**Re: Del Taco**  
**1500 Gibson Blvd. SE**  
**30-Day Temporary Certificate of Occupancy**  
**Transportation Development Final Inspection**  
Architect's Stamp dated 10-12-21 (L15-D049)  
Certification dated 08-10-23

**Re: Del Taco**  
**1500 Gibson Blvd. SE**  
**Project # BP-2021-53946**  
**Approved TCL Architect's Stamp 10-12-2021 (L15D049)**

DEL TACO STORE  
ENLARGED SITE PLAN  
1500 GIBSON BLVD  
ALBUQUERQUE, NM  
PROJECT #2107

SHEET NUMBER AS-1.1

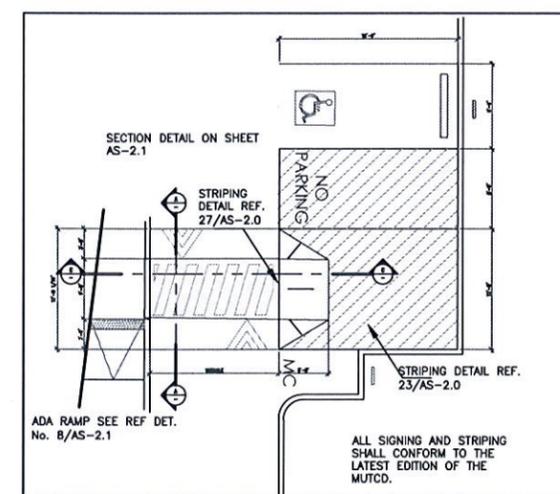
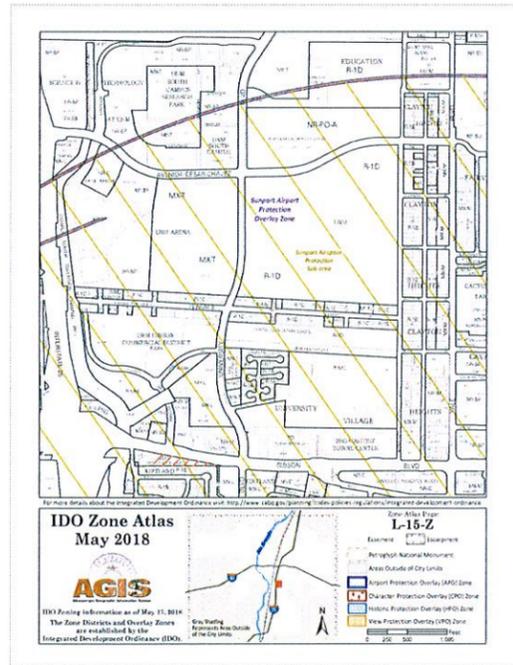
- Per the approved site plan, 10 parking spaces are required. Per site visit, only nine parking spaces have been provided. Please address this concern.
  - The pavement marking "MC" should be shown in the opposite direction for motorcycles entering the parking space.
- Tripping hazard, please fix the installation of the truncated domes at the west side of site access.

Once these corrections are complete, email pictures to [malnajira@cabq.gov](mailto:malnajira@cabq.gov) for release of Final CO.
